**ADDENDUM No. 2**

Date: June 5, 2026

Project: Hector International Airport  
Terminal Apron Reconstruction – Phase 2

**3 EXISTING VALVE MANHOLE 3 MODIFICATIONS**  
1" = 2'

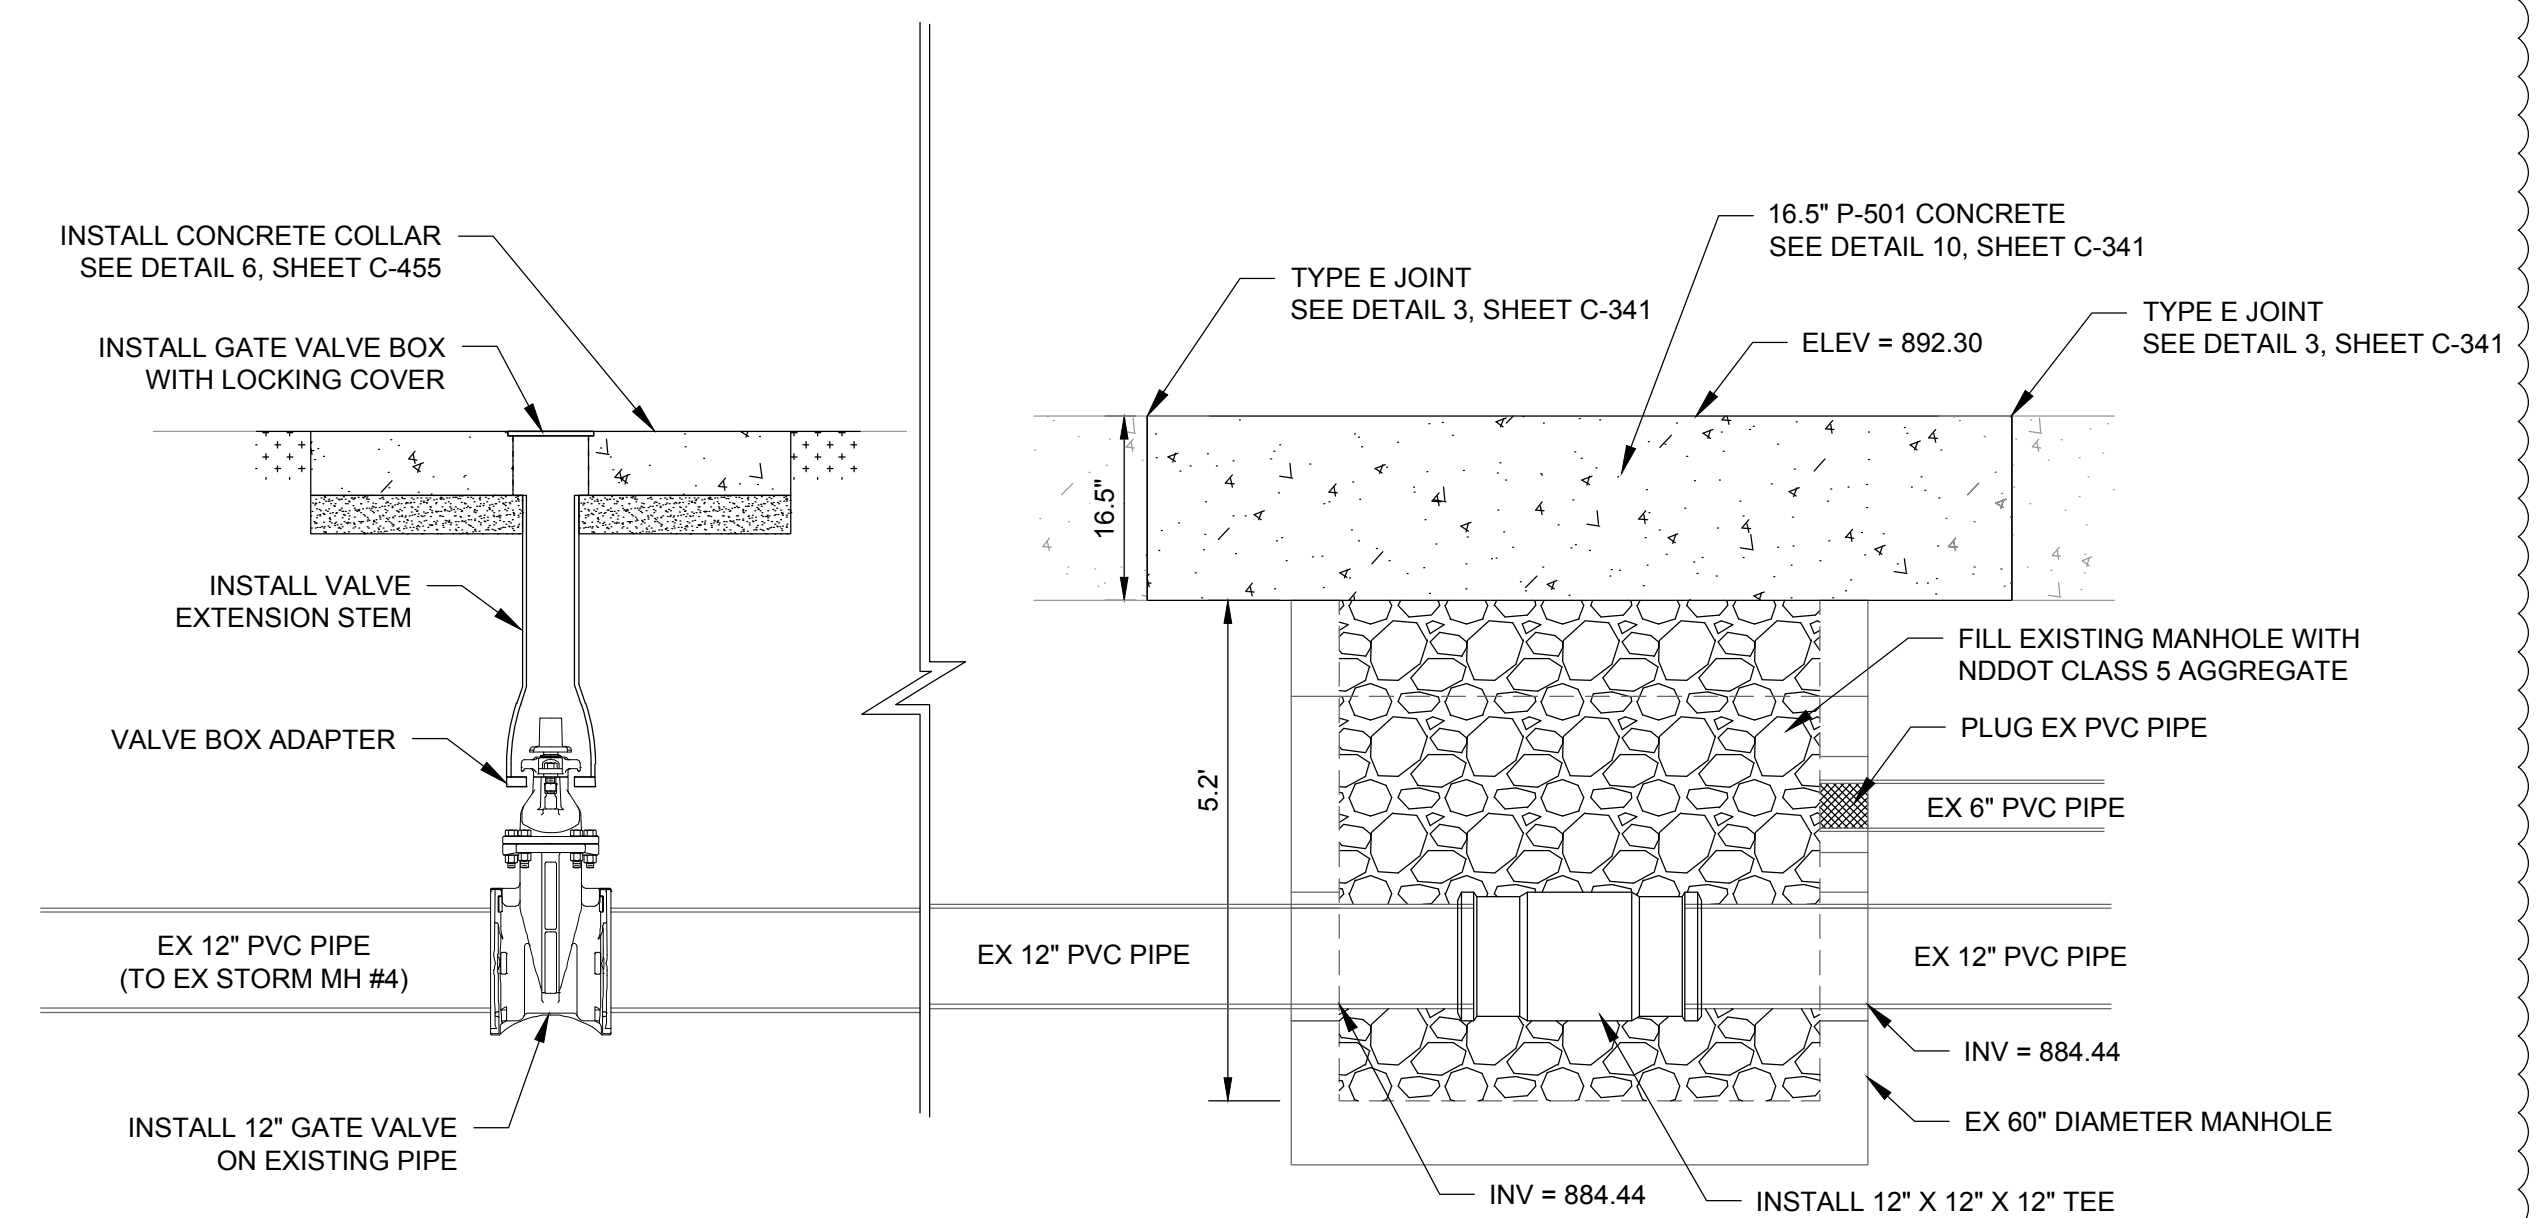
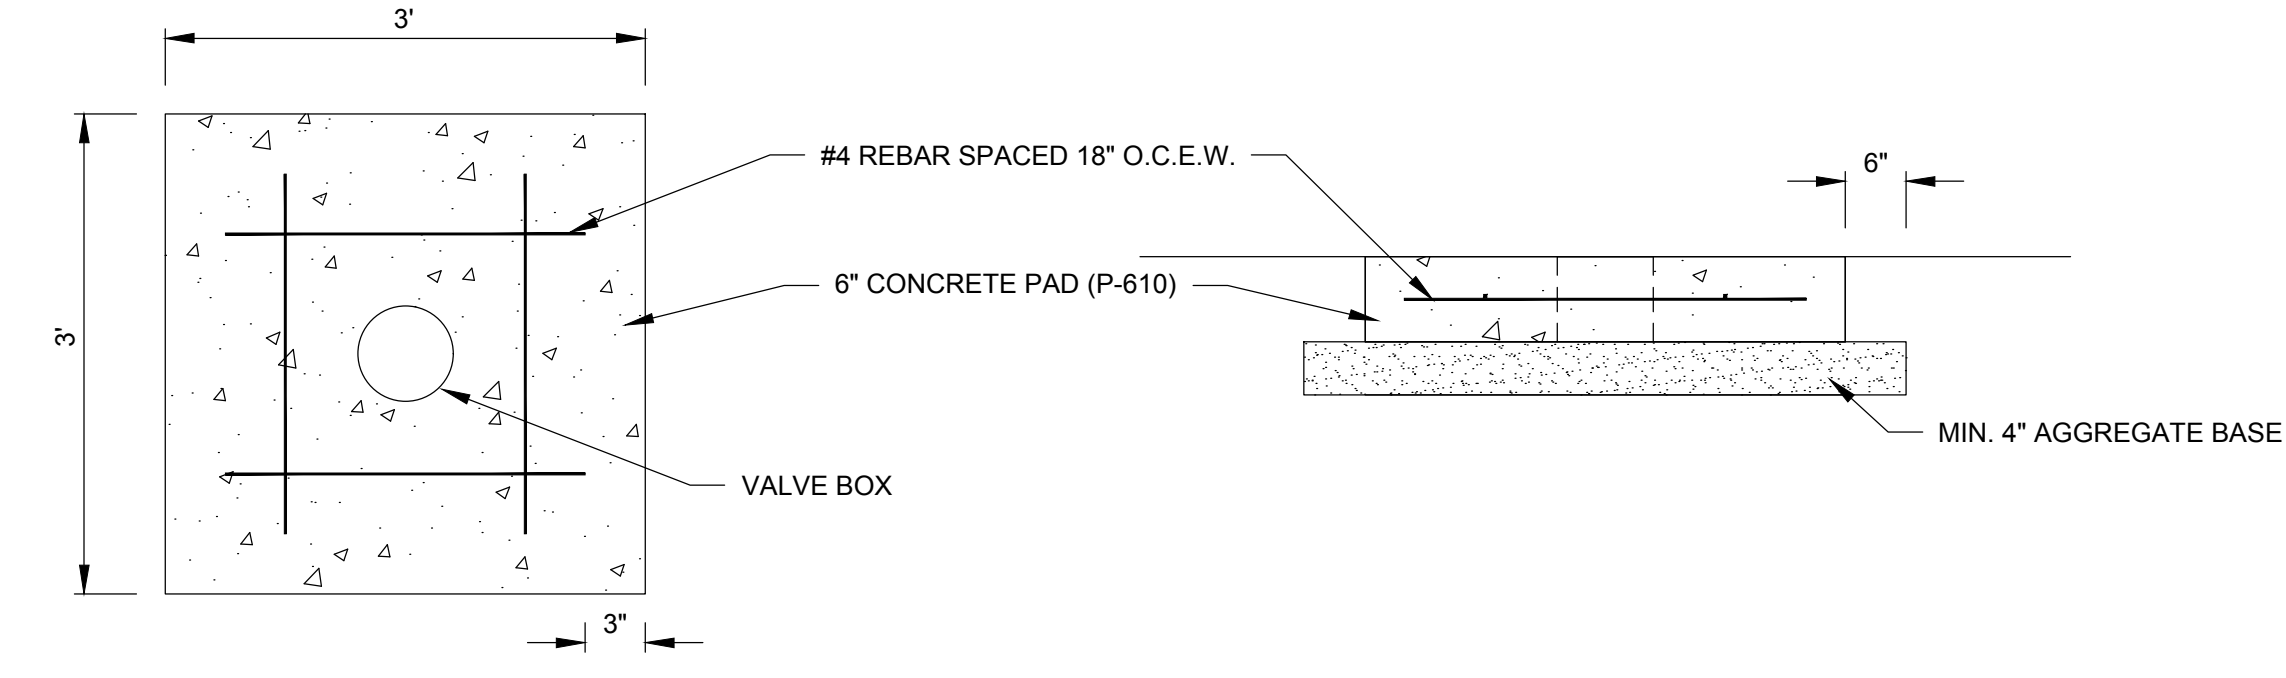
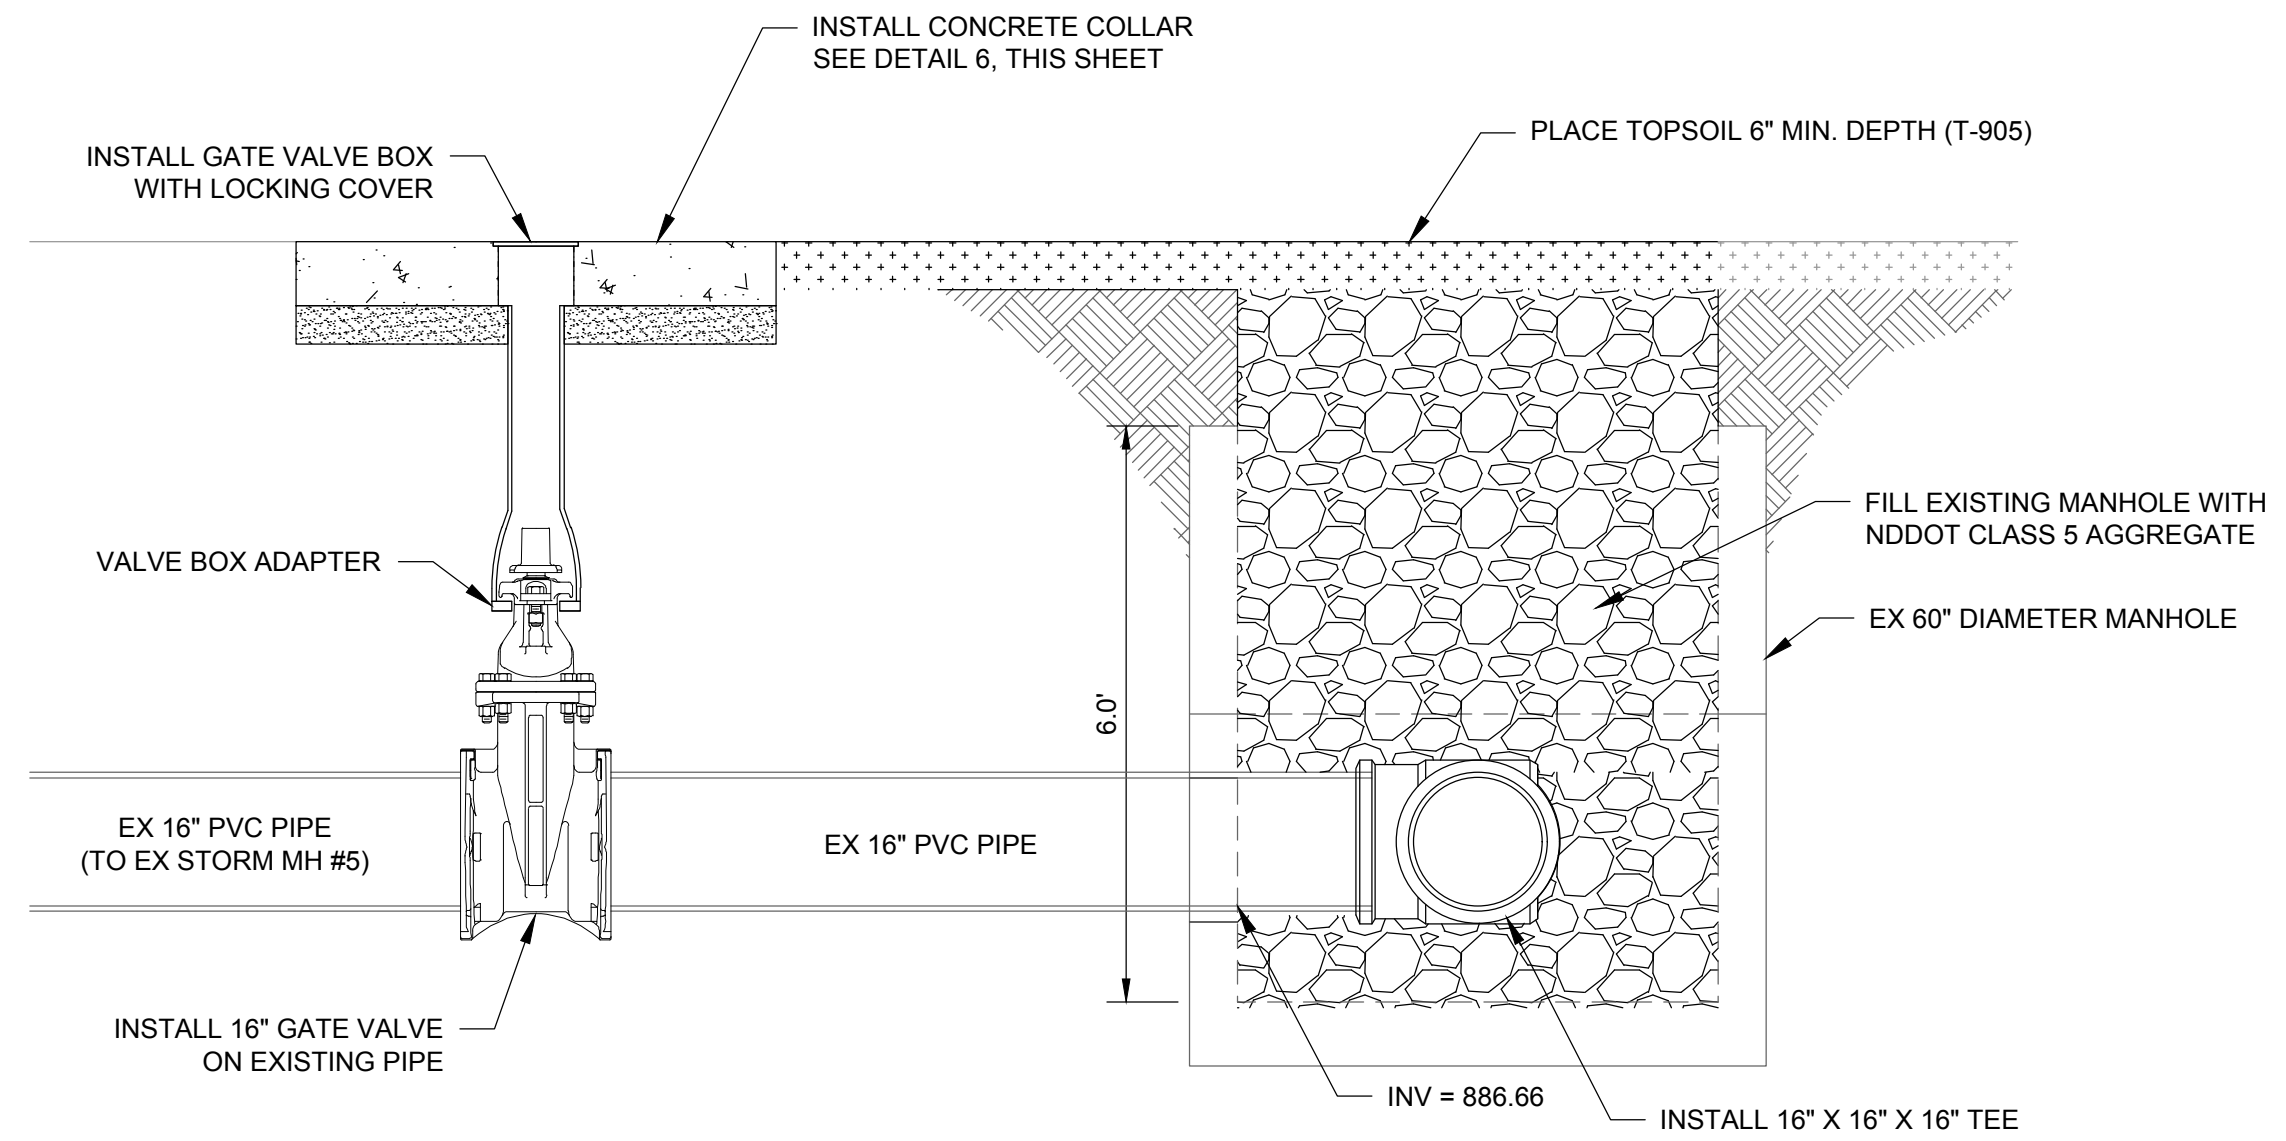
**7. Sheet C-455 VALVE MANHOLES MODIFICATIONS**

- A. Add sheet
- B. Changes include
  - I. Moved Detail 5 *Existing Valve Manhole 5 Modification* from sheet C-454
  - II. Added Detail 6 *Gate Valve Cover Concrete Collar*
  - III. Revised notes
